September 22, 2022

Version 3

MIL Is ON with DTC P0455

Supersedes 21-007, dated September 2, 2022, to revise information highlighted in yellow.

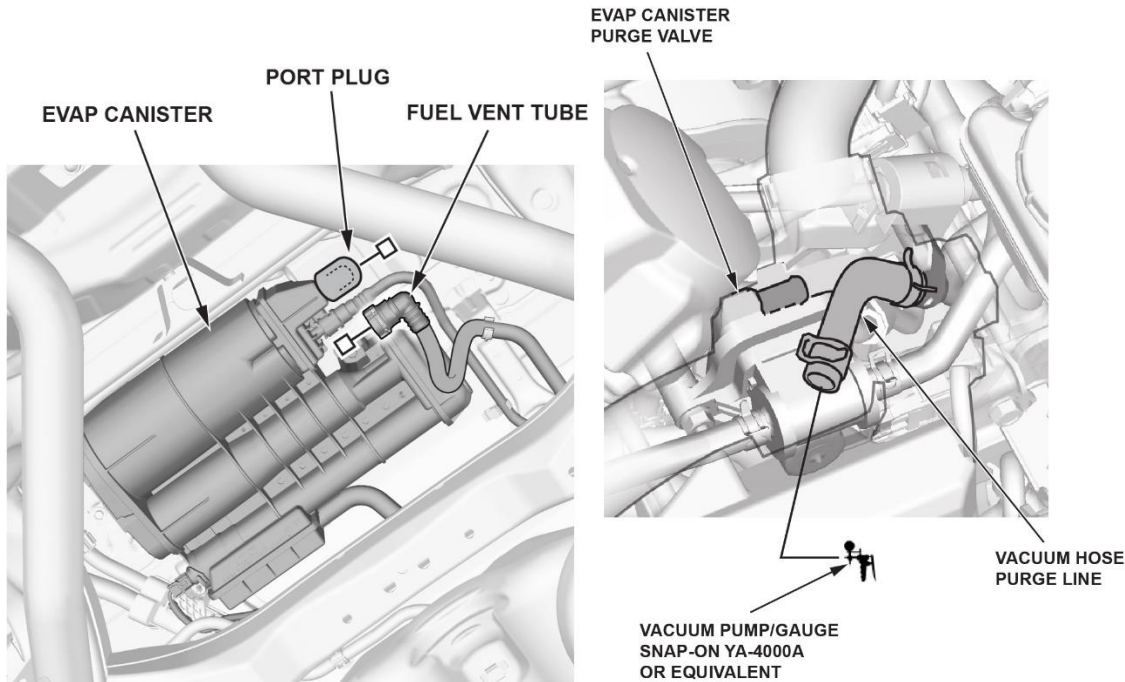
Under INSPECTION PROCEDURE, steps 6 and 10 were revised.

9. Select CVS ON and apply vacuum to the hose until it reads **1.90 V**.

10. Go to the PGM-FI data list and monitor the FTP sensor voltage.

- If the FTP sensor voltage does not increase more than **0.2 V**, the system is normal. Go to step 11.
- If it does, this bulletin does not apply. Continue with normal system troubleshooting.
